SERVICE BULLETIN

APPLICABILITY: 2013-16MY BRZ

NUMBER: 09-54-12R

SUBJECT: High-Pitched “Chirp,” “Squeak” or “Cricket”
 Sound from the Engine

DI FUEL PUMP ASSEMBLY

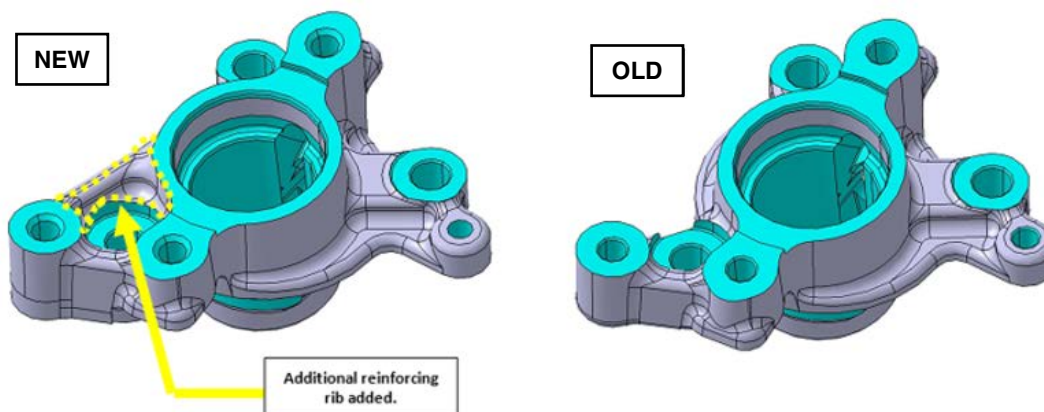
Not all DI pumps may exhibit this sound. Some vehicles may have components which in combination with certain fuel temperatures and / or formulations, may result in aeration of the fuel within the body of the pump and cause this sound. **This result is non-detrimental to the vehicle.** Production changes have been made to eliminate the source of the sound.

VIN RANGE	REQUIRED PART REPLACEMENT(S)		
	DI Fuel Pump	Drive Case	Rocker Cover LH
Prior to F*603025	YES	YES	YES
F*603026 to F*603363	YES	NO	YES
F*603364 to G*604648	YES	NO	NO

- A new fuel pump sealing ring (o-ring) is included with the new pump assembly.
- The required tool for high-pressure fuel pump removal / installation is: Socket Driver, Snap-On Tools stock# **FTX40TPE, TORX® Plus, size 40 IP, length: 1¾”** (see July, 2012 TIPS).
